SUBJECT: ISSUANCE OF AMENDMENT NO. 18 TO FACILITY OPERATING LICENSE
R-75 - OHIO STATE UNIVERSITY RESEARCH REACTOR (OSURR)
(TAC NO. MC5198)

AMENDMENT TO FACILITY OPERATING LICENSE

Amendment No. 18
License No. R-75

ENCLOSURE TO LICENSE AMENDMENT NO. 18

Figure 6.1: Administrative Organization

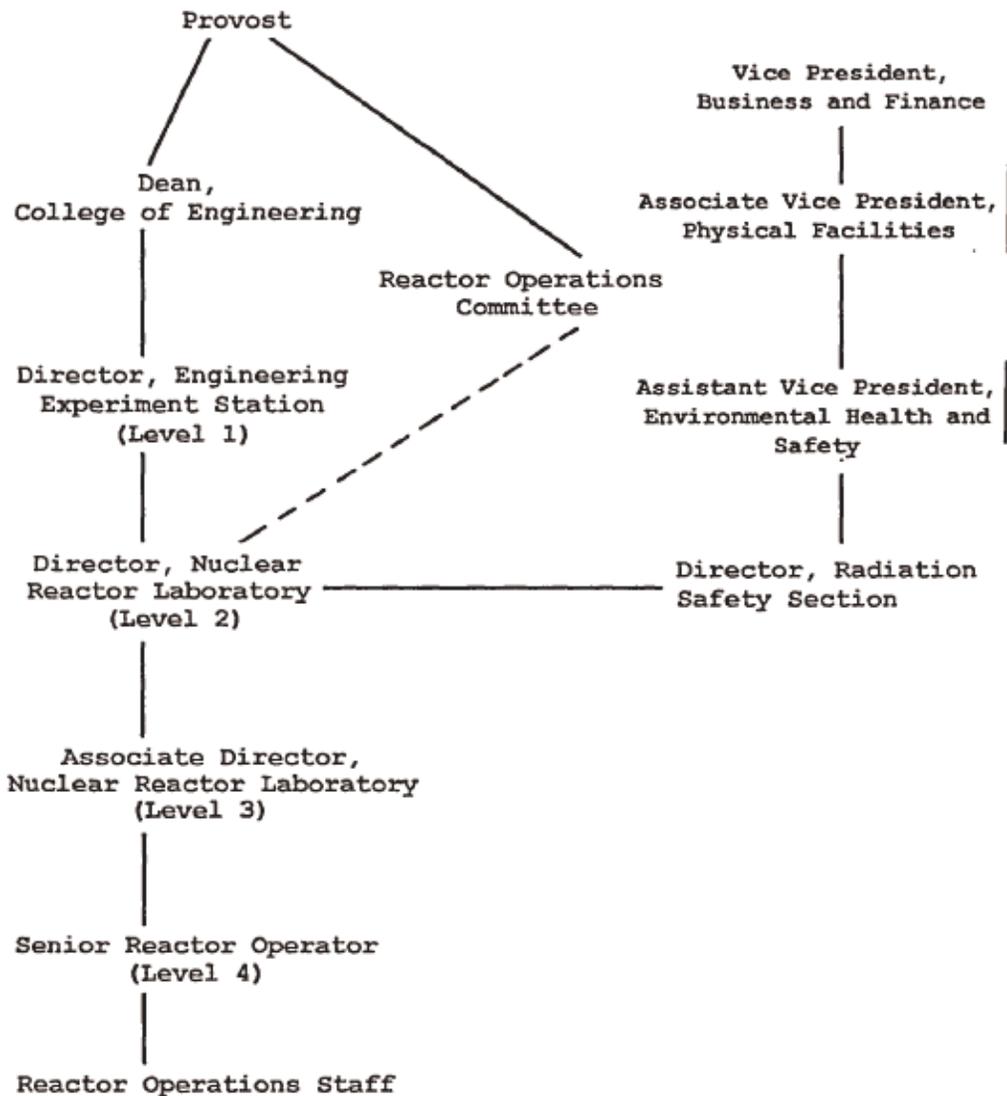
The amendment adds two existing positions between the Vice President of Business and Finance and the Director of Radiation Safety Section to the Administrative Organization, Figure 6.1 of the Technical Specifications (TS). Those positions are the Assistant Vice President of Physical Facilities and the Associate Vice President of Environmental Health and Safety.

The proposed change to Figure 6.1 of the OSURR TSs adds two positions between the Vice President of Business and Finance and the Director of Radiation Safety Section to the Administrative Organization. Those positions are the Assistant Vice President of Physical Facilities and the Associate Vice President of Environmental Health and Safety. The licensee states that the addition of these two positions does not lessen the independence of the Radiation Safety Section from the OSU Nuclear Reactor Laboratory, of which the OSURR is a part. They indicate that the Director, Nuclear Radiation Laboratory, reports to the Provost, also the Executive Vice President, and the Director, Radiation Safety Section, reports to the Senior Vice President for Business and Finance. The licensee explains that the Provost and the Senior Vice President are independent and report directly to the University President, which is no less independent than the structure prior to the change.

The Director, Radiation Safety Section has the responsibility for implementing the radiation protection program at the OSURR. Section 6.3 of the American National Standard ANSI/ANS 15.1 - 1990, "The Development of Technical Specifications for Research Reactors," states that

the individual or group responsible for implementing the radiation protection program shall report to level 1 or level 2 of the OSURR Management. In the case of the OSU, both before and after the TS change, the Director, Radiation Safety Section report to above level 1. The NRC staff finds that the independence of the Radiation Safety Section from the OSU Nuclear Reactor Laboratory is not lessened by this change. The health and safety of the public is not diminished by this change thus the staff finds it acceptable.
